From: Devlin Fortuin <Devlin.Fortuin@westerncape.gov.za>
Sent: Monday, 30 October 2023 14:16
To: Dale Holder
Cc: Vanessa Stoffels
Subject: (Job 25208) DRAFT REPORT FOR THE PROPOSED SUNVELD SOLAR PV AND BATTERY ENERGY STORAGE (BESS) FACILITY ON FARM KRUISPAD 120 AND ON THE FARM DOORNFONTEIN A 118 SITUATED APPROXIMATELY 7.5 KM EAST VELDDRIF IN THE BERG RIVER MUNICIPALITY OF THE WESTERN CAPE...

NOTIFICATION OF AVAILABILITY OF DRAFT ENVIRONMENTAL IMPACT REPORT FOR THE PROPOSED SUNVELD SOLAR PV AND BATTERY ENERGY STORAGE (BESS) FACILITY ON FARM KRUISPAD 120 AND ON THE FARM DOORNFONTEIN A 118 SITUATED APPROXIMATELY 7.5 KM EAST VELDDRIF IN THE BERG RIVER MUNICIPALITY OF THE WESTERN CAPE PROVINCE.

Table 16: Assessment of the likelihood of occurrence of Species of Conservation Concern identified in literature as possibly occurring within the Study Site (Biodiversity Africa, 2024)."

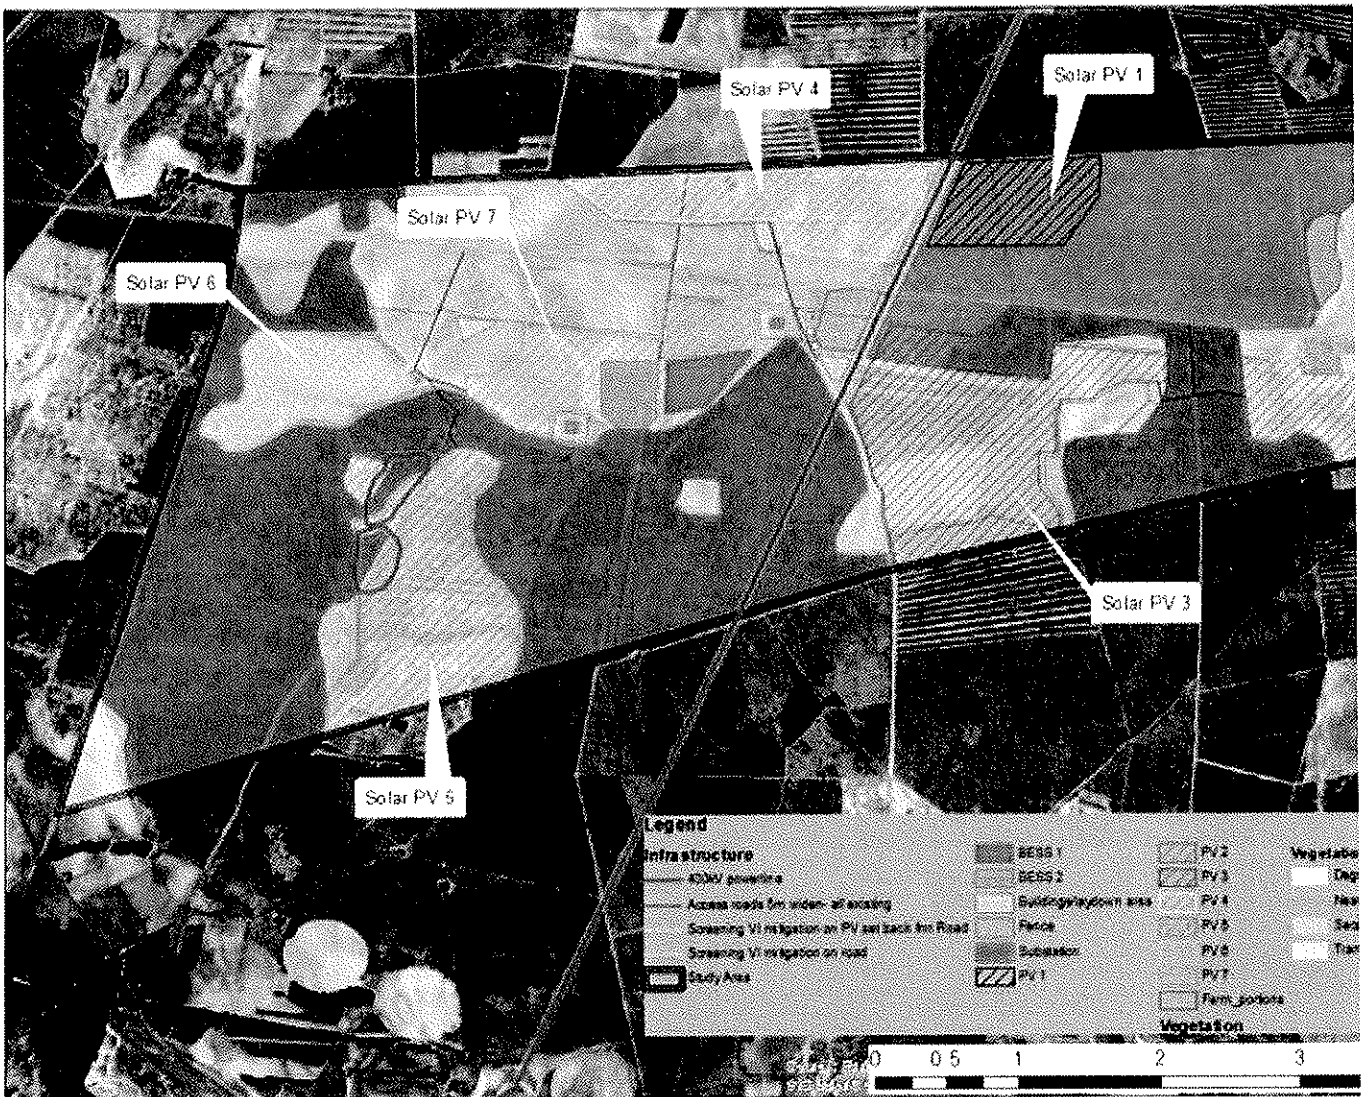
Comment: Therefore there is a great loss in Saldanha Flat Strandveld, secondary vegetation and loss of plant species of conservation concern due to large extent of indigenous vegetation clearance. How will this be mitigated?

This section in draft BAR related to a discussion on the botanical component of the entire study site which included that affected by the development footprint as well as areas that were avoided due to their sensitivity. The footprint of the development was however designed in such a way as to avoid all of the near intact Saldanha Flats Strandveld with the exception of a small fragmented portions as highlighted in red in the image below.

There is a small area of 9.1ha of near-intact vegetation and 15.8ha of degraded vegetation that will be impacted by project infrastructure which the specialist found this to be of low significance after mitigation. To account for this loss, areas within the study area, that will not be affected by project infrastructure, will need to be rehabilitated (alien vegetation managed) and set aside as conservation areas. The loss of a small subpopulation of *Leucospermum rodolentum* must be mitigated by ensuring that set aside areas include this species and that these subpopulations increase in size over time to account for the loss of the subpopulation to Solar PV 1. This would result in a net gain of Saldanha Flats Strandveld and *Leucospermum rodolentum* over the long term. Protected species that can be easily and successfully translocated, will have to be moved into surrounding undeveloped areas on the same property as part of the rehabilitation efforts.
